1. Historic District Commission Virtual Meeting

Historic District Commission Meeting

HDC Work Permit Staff Review

Property address: 206 E Forest

1 ROOF PLAN

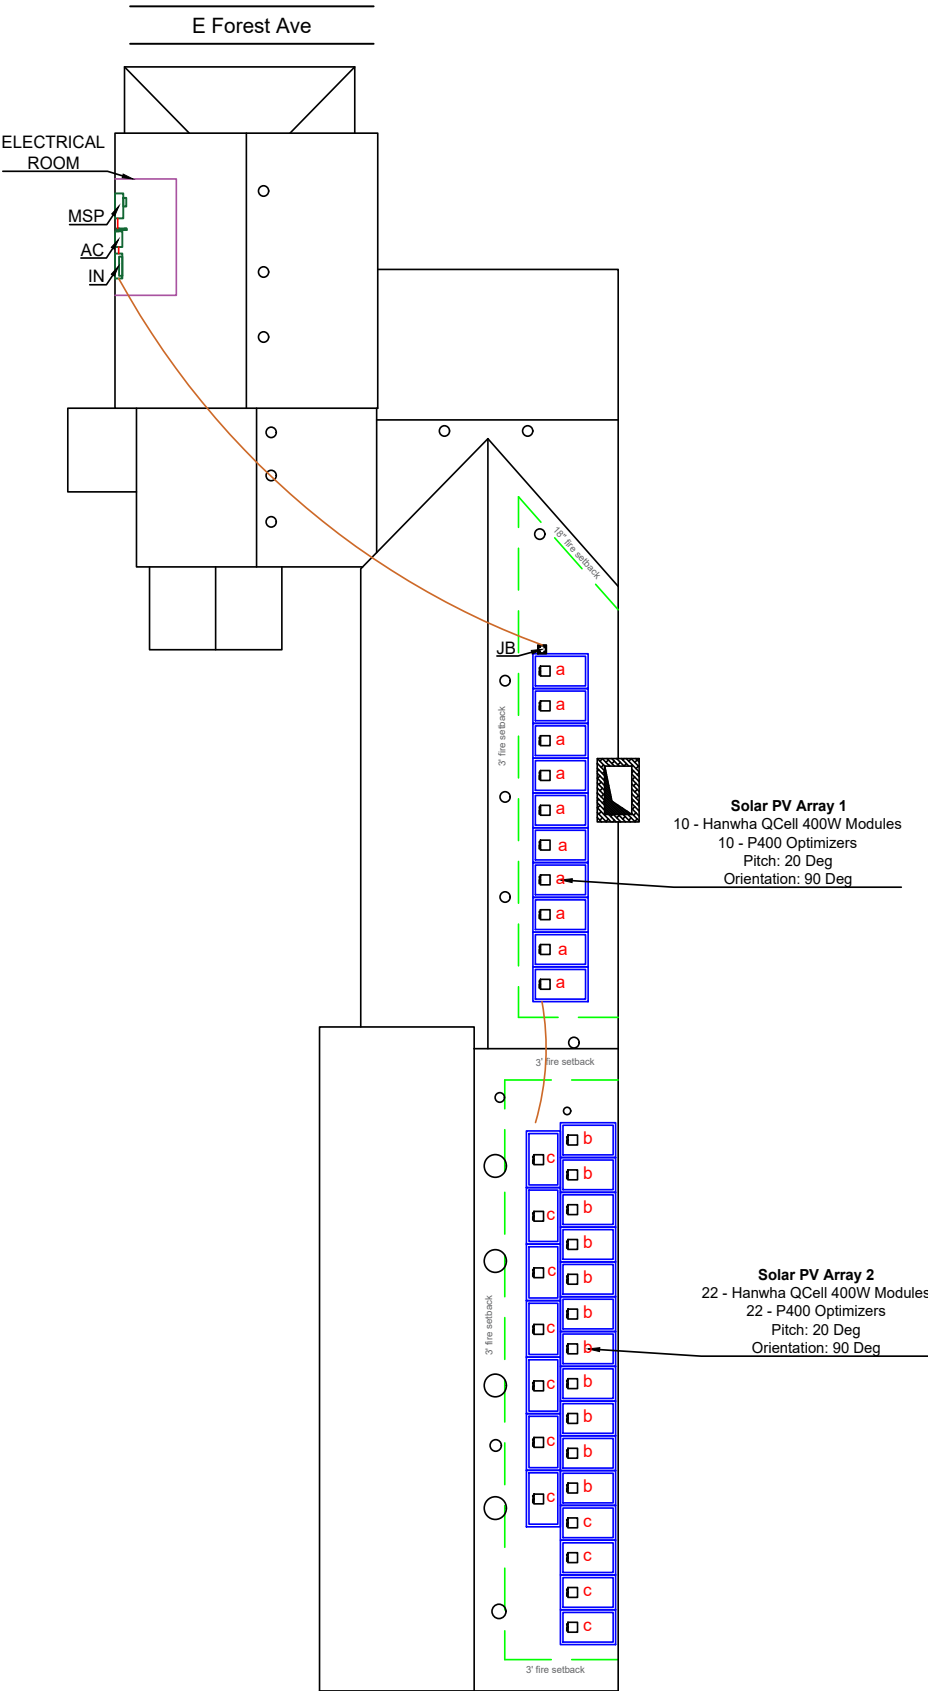
1. The applicant proposes to install two sets of solar arrays on the east roof slopes of the rear additions.
 - a. The northern array will have 10 modules.
 - b. The southern array will have 22 modules. (32 Total Modules)
2. The new arrays will be mounted at a 20-degree angle, approximately the same angle as the roof slope.
3. The inverter and disconnect systems will be mounted to the west elevation of the original house, at the location where electricity enters the house.
4. The application appears to generally meet the requirements of the HDC Alternative Energy Fact Sheet.

Move to approve and issue a Certificate of Appropriateness for the work at 206 E Forest as submitted in the application on August 3, 2021, for installation of a solar array and power apparatuses as specified.
